Subject: RE: EPR-BX1942IX-V004 Milegate Extension Landfill Site - We need more information about your application

Subject: EPR-BX1942IX-V004 Milegate Extension Landfill Site - We need more information about your application

There is a discrepancy between the thermal input values quoted in the plant list spreadsheet and the Table GRA6: Modelled Flare and Engine Characteristics (pg 13, Landfill Gas Risk Assessment.)

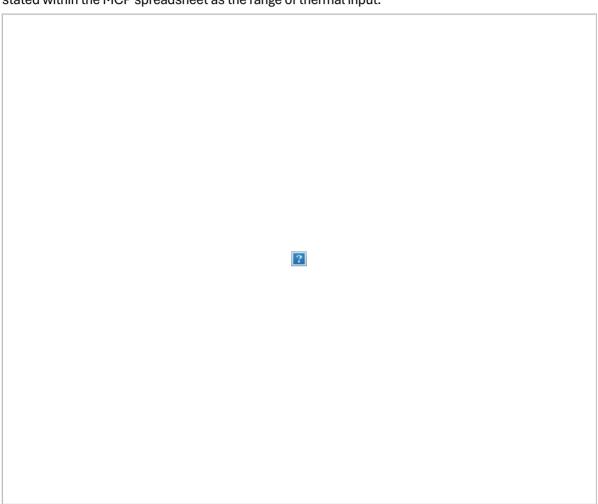
Please can you clarify the correct values.

We are uncertain as to the inconsistency in values you refer to as the thermal input values are not stated within Table GRA6 (reproduced below). For clarity, the 190 kW under the type of engine in the table refers to the Continuous Power (COP) rating of the proposal plant. The COP is the minimum power the engine can continually operate at, and is not the same as the thermal input of the proposed operations. As stated in our non-duly made response letter of 6 June, The MW thermal input of each engine has been calculated based upon the following equation taken from the Association of Manufacturers of Power Generating Systems (AMPS) method, referenced by Environment Agency guidance:

Pth = V*Hg/3.6

Where: Pth is the thermal input power (kW);

V is the micro-generator capacity (m³/h); and

Hg is the heating value of gas taken from the Digest of UK Energy Statistics (DUKES) produced by the Department for Energy Security & Net Zero (DESNZ) (MJ/h).

Based upon the micro-generator capacity of up to $114 \, \text{m}^3/\text{h}$ from the engine specification (stated as the maximum of the range in table GRA6), and heating value of $19-23 \, \text{MJ/m}^3$, the estimated MW thermal input for each engine would be between $0.602 \, \text{and} \, 0.728 \, \text{MW}$, therefore the combined MW thermal input for the two engines would be between $1.204 \, \text{and} \, 1.456 \, \text{MW}$. These two values are stated within the MCP spreadsheet as the range of thermal input.
